**TURTLE CREEK SUBDIVISION**  
**PHASE II**

**Revised from the June 1<sup>st</sup> meeting**

APPLICATION NUMBER Holdover DATE July 6, 2006

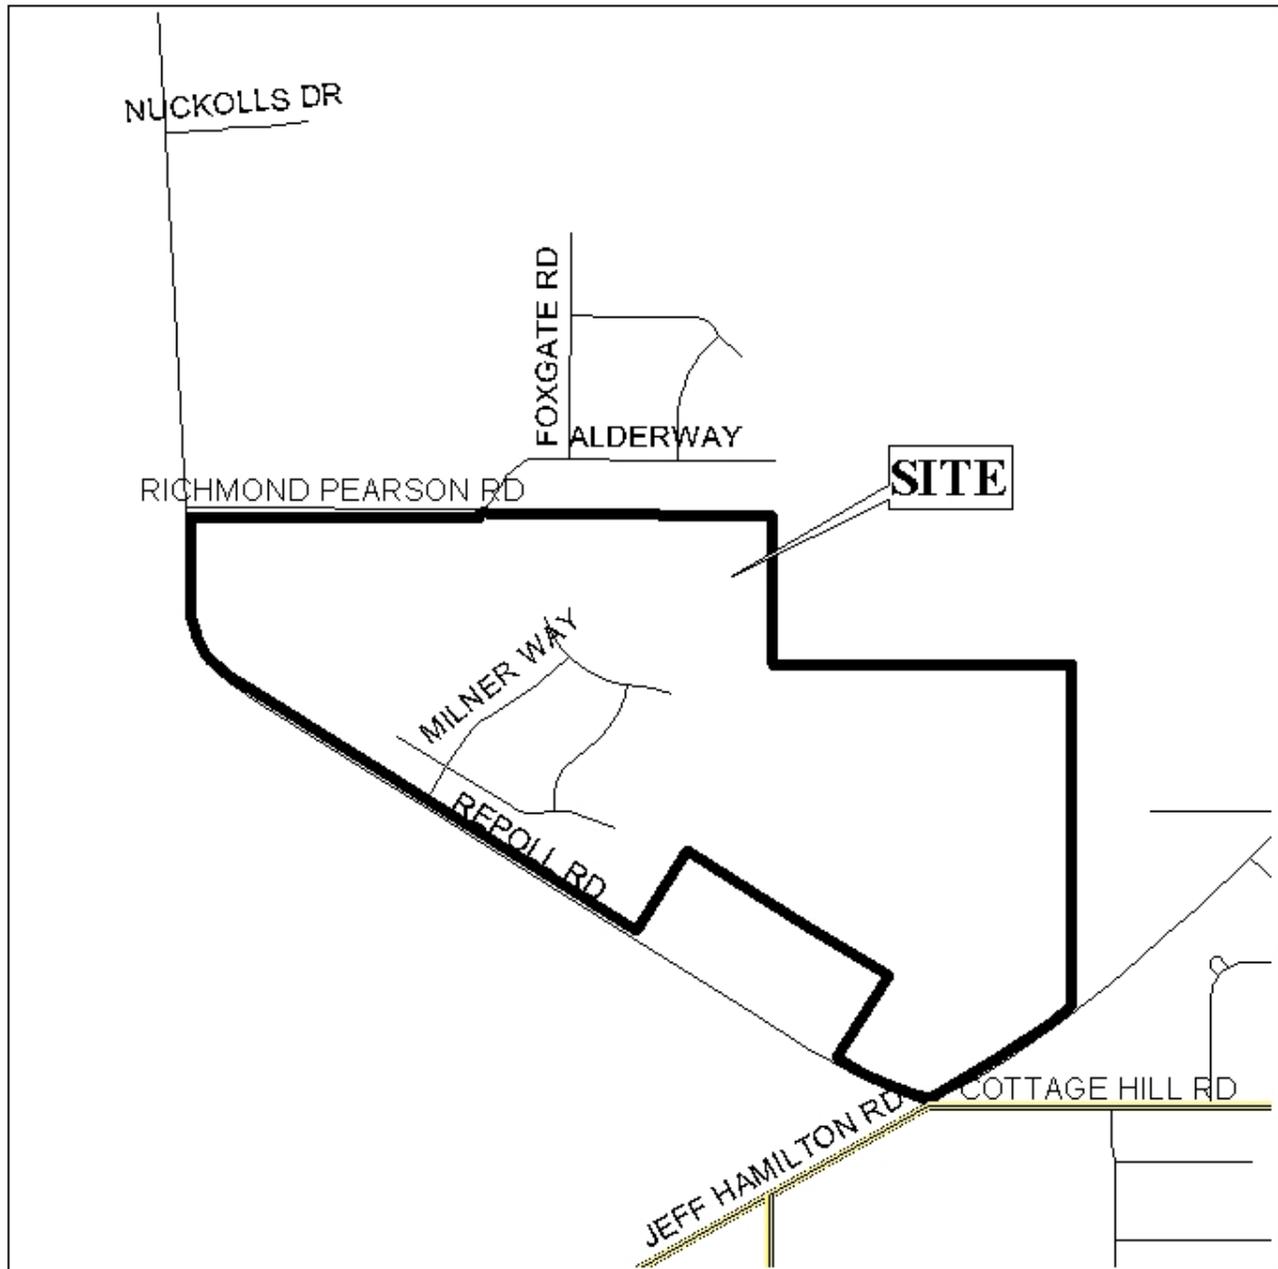
*The applicant has submitted a revised plat that reflects the remainder of the aprent parcel and an adjacent parcel which are depicted as future development.*

*The purpose of the application is to remove a condition of the previous approval which required a street stub to the East to provide access to the remainder of the parent parcel, which would have been landlocked based upon the plat submitted. The applicant's justification for removal of the street stub condition is two-fold; first, the stub would have to cross an existing water and sewer line and easement; and second, it is the applicant's plan that the property on the East side of the water and sewer easement will be developed as a separate subdivision with a different market base and style of home.*

*In addition to the necessary inclusion of the remainder of the parent parcel and adjacent parcel as future development, the applicant submitted a conceptual layout of the future development area. This conceptual layout contained over 175 lots and only one point of access. While a street stub to the North was shown, there is no street to the North to which the stub would eventually connect.*

*Therefore, based on the total number of lots proposed for Turtle Creek (162), and the potential development of the property adjacent to the East, the requirement for a street stub to the East is still valid and should remain a condition of approval.*

*Based on the preceding, the plat meets the minimum requirements of the Subdivision Regulations and is recommended for Tentative Approval, subject to the following conditions: (1) the provision of a street stub to the East, exact location to be coordinated with Urban Development Staff; (2) the entire parcel(s) to the East be shown on the final plat as Future Development; (3) placement of a note on the final plat stating that maintenance of all common areas shall be the responsibility of the property owners association; (4) placement of a note on the final plat stating that no lots shall have direct access to Repoll Road or Richmond Pearson Road; and (5) developer to obtain all necessary federal, state and local approvals prior to the issuance of any permits.*
